INVITATION FOR BIDS

Construct Support Services Building
New Environmental Quality Management Center

ADDENDUM #2

04/02/2025

C-30

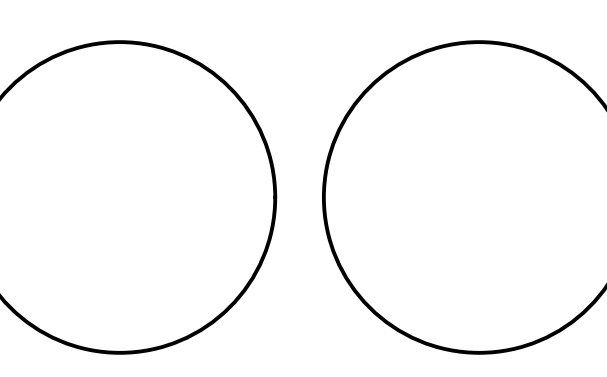
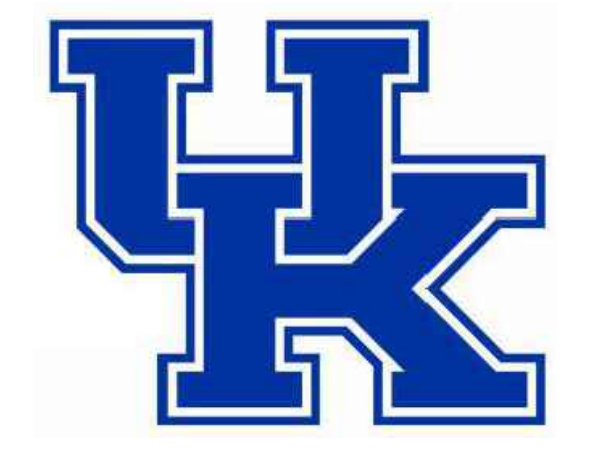
“6. Provide Site Construction Fencing and Gates. See Section 003132 Site Logistics Plan for reference. All fencing shall be new, 8’-0” tall, with a top rail and bottom wire. All Construction Gates shall be sliding-type. Include temporary lighting on west perimeter of site construction fencing. Include removal and disposal of all within this sub-section.”
5. Refer to Section 00 2413.13 Scope of Work – Trade Category **TC01 – Earthwork & Site Utilities**, Page 00 2413.13 – 3. Delete B.8.b and replace with the following:

C-30

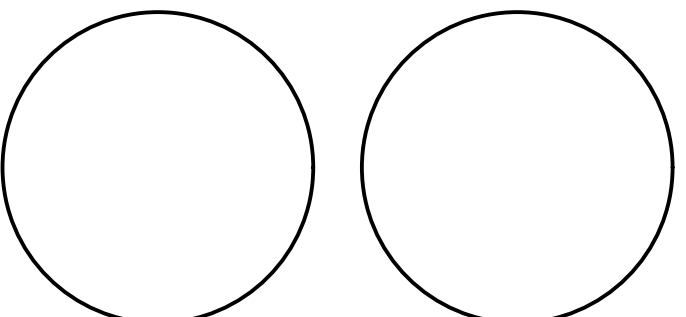
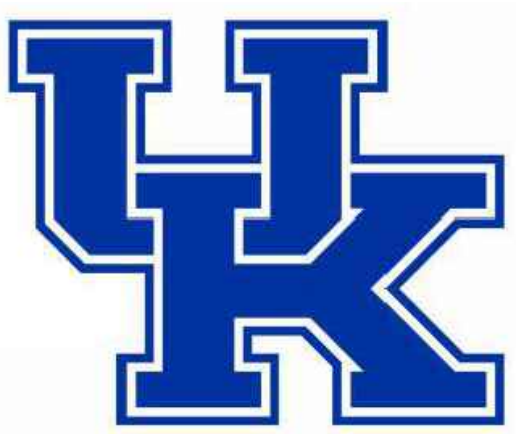
Lighting to be provided on Railroad Track side of site fencing

Site Construction Fence

Site Construction Gate (Sliding)
